Re: Objections to the Proposed Right-of Way, Final EIS, and Draft Record of Decision for the Greenlink North Transmission Project

Project: Greenlink North Transmission Project.

Responsible Official and Forest/Ranger District: Jon M. Stansfield, Humboldt-Toiyabe Forest Supervisor

SWIP Existing Structure

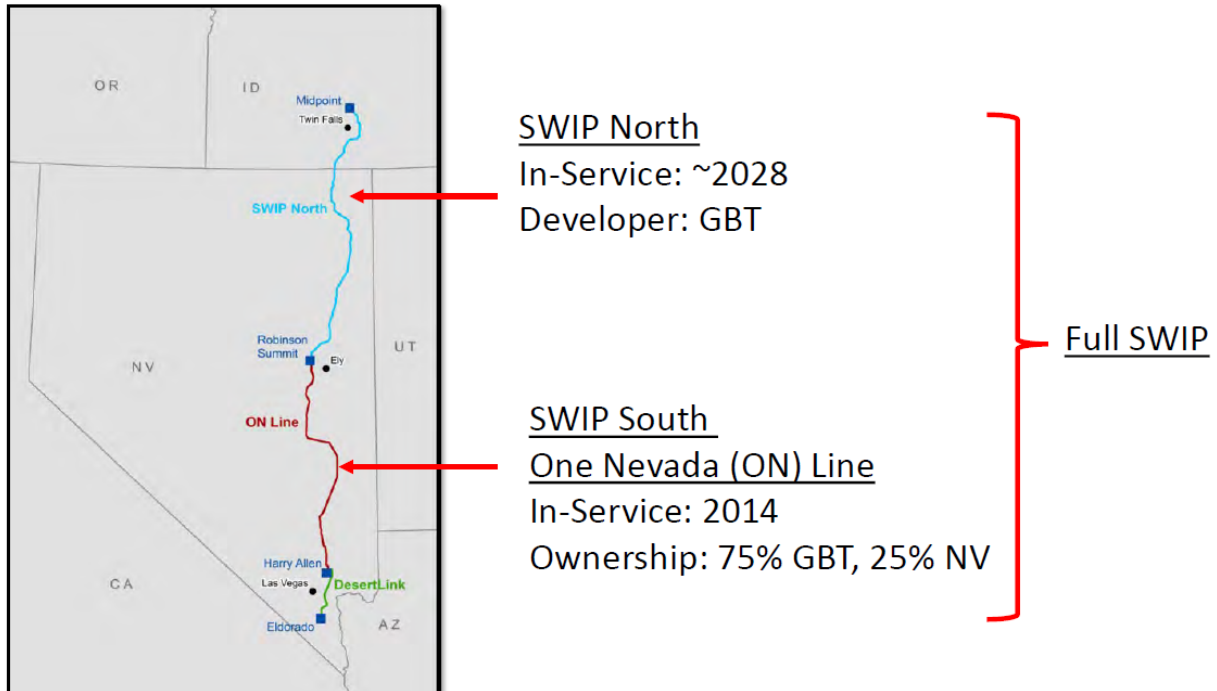
The FEIS also fails to address why the planned Southwest Intertie Project (SWIP) North line between the Wells and Robinson substations could not provide the needed redundancy, as suggested in the Center’s DEIS comments. FEIS at C-22. According to a public filing, Nevada Energy has contracted for nearly half of SWIP North’s 2,000-MW capacity in each direction:

In other words, “NV Energy will hold 952.5 MW of SWIP-North Line transmission capacity north to south and 847.5 MW of SWIP-North Line transmission capacity south to north.”⁷ But the FEIS does not address why Nevada Energy could not use the SWIP-North line, in conjunction with the Churchill-to-Wells I-80 route, to support its need for transmission redundancy. Potentially, given Nevada Energy’s rights to this significant available capacity, no new line between Wells and the Robinson Summit substation would need to be built to have transmission redundancy between Wells and Robinson substation.

In any case, if building an additional line between Wells and Robinson Summit would be required to meet the project need to increase transmission redundancy—and would in fact meet the project need, as BLM says—BLM fails to take the next logical step of addressing whether development of the additional line would be feasible, or why it still need not be considered in the EIS. Potentially that new line could be built within the same ROW as SWIP North,⁸ which would go from the Wells area (line crosses about 29 miles to the east of Wells) to the Robinson substation. And construction of the additional line within an already approved utility corridor would minimize the challenges and costs of developing the new line.
